Sub: Clarifications No. 01 Notice for Design, Supply, Construction, Erection, Installation, Testing and Commissioning of 05 Nos. 33/11kV New GIS Substation, 01 Nos. 33/11kV Substation (GIS Up-gradation), 33kV Bay-Extension at 02 Nos. Substation and 33kV Underground Cable Double Circuit Source Line with Civil and other related works including automation of the Sub-station (SAS) on Turnkey Basis under Power Distribution System Development, Chattogram Zone (2nd Phase), BPDB, Chattogram (GD-1, Lot-4).

Addendum-1

International Tender Ref. No.: 27.11.0000.101.14.035.22-3232, Dated- 20/07/2022 for "Design, Supply, Construction, Erection, Installation, Testing and Commissioning of 05 Nos. 33/11kV New GIS Substation, 01 No. 33/11kV Substation (GIS Up-gradation), 33kV Bay-Extension at 02 Nos. Substation and 33kV Underground Cable Double Circuit Source Line with Civil and other related works including automation of the Sub-station (SAS) on Turnkey Basis under Power Distribution System Development, Chattogram Zone (2nd Phase), BPDB, Chattogram," (LOT-4)

| Drawing No. : | A-3 |

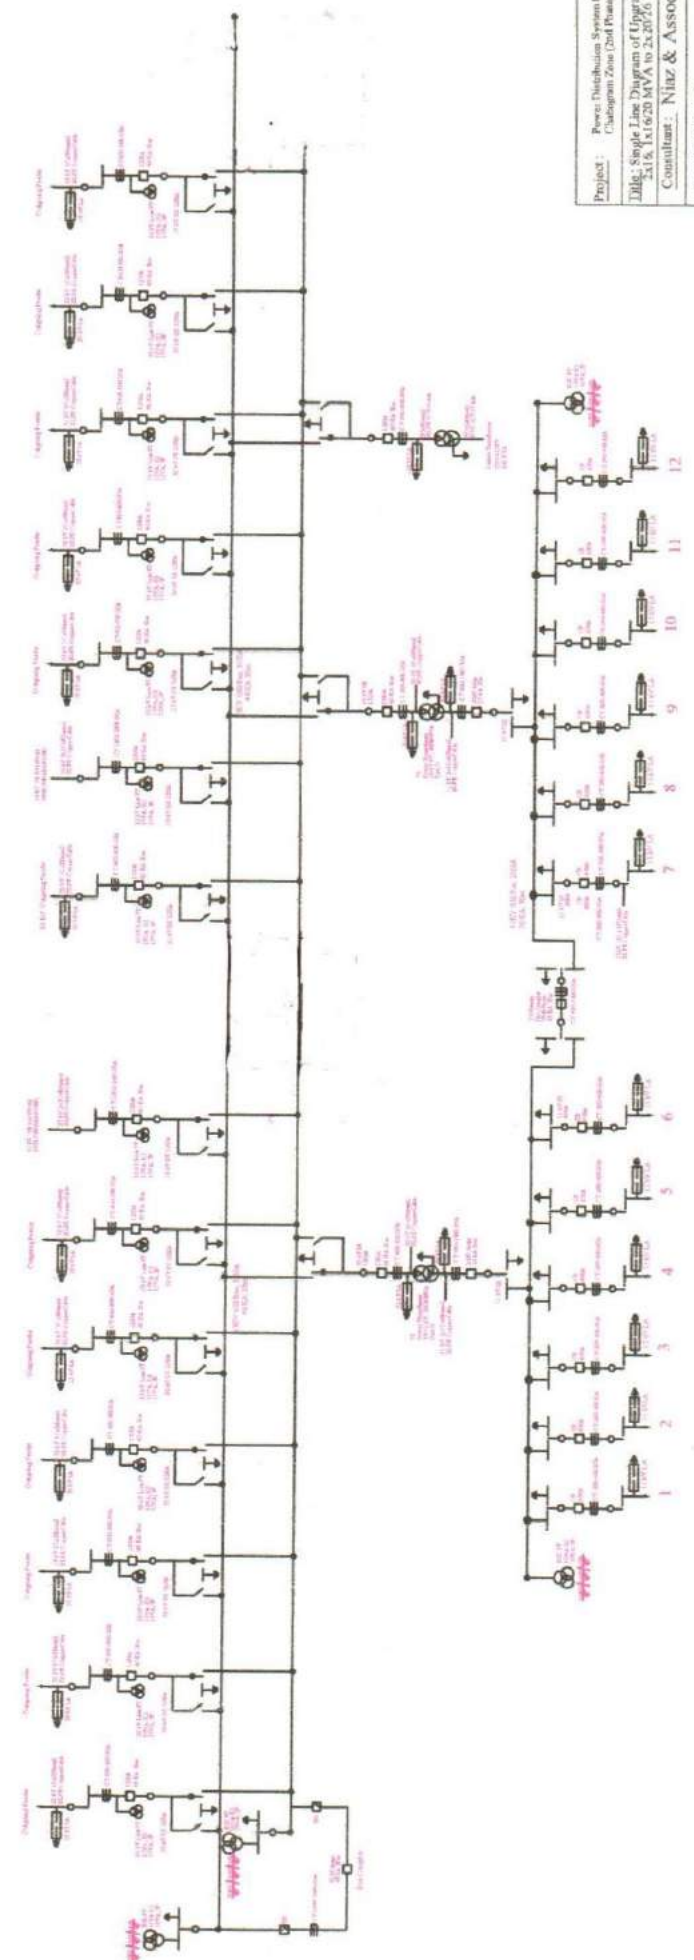
| Sl. No. | Tender Clause & Page No. | Existing as in Tender Document | Clarification Asked | Amendment/ Clarification/ Remarks |
|---------|--|---|---|---|
| 49 | Price Schedule, 33kV GIS Line Item, Description of Items for Up-gradation of GIS Substation at Sholoshohor | Description of Items for 33kV GIS mentioned that, GIS cubicles Bus Coupler Breaker with Riser (Bus Coupler with Riser) (2000A) -1 No. | <p>We understood that, 33kV GIS for this substation is Double Bus Bar system. As per the indicative Single Line Drawing, 1 set of Bus sectionalizer shown and in Price Schedule these 1 set is mentioned as Bus Coupler.</p> <p>Kindly note that, if this 1 set is Bus Sectionalizer, there are also requirement of 2 nos. additional Bus Coupler Panels of 3150A (1 no. for each Bus Section) which are not mentioned in the Price schedule and also not shown in the indicative Single Line Drawing.</p> <p>Also total 4 sets (12 nos.) of Bus PTs are required for 2 section of the Bus Bars which are also not clearly mentioned in the Price Schedule or indicative drawing.</p> <p>Kindly clarify and confirm the exact requirement.</p> <p>Kindly recheck the ratings as it seems its not correct. Incoming may be 2500A and Bus Coupler with Riser will may be 3150A. Kindly confirm.</p> | <p>No bus section required. Only one set of Bus Coupler with riser required. for Double Bus system (Corrected indicative drawing given as attachment-2 of this clarification)</p> |
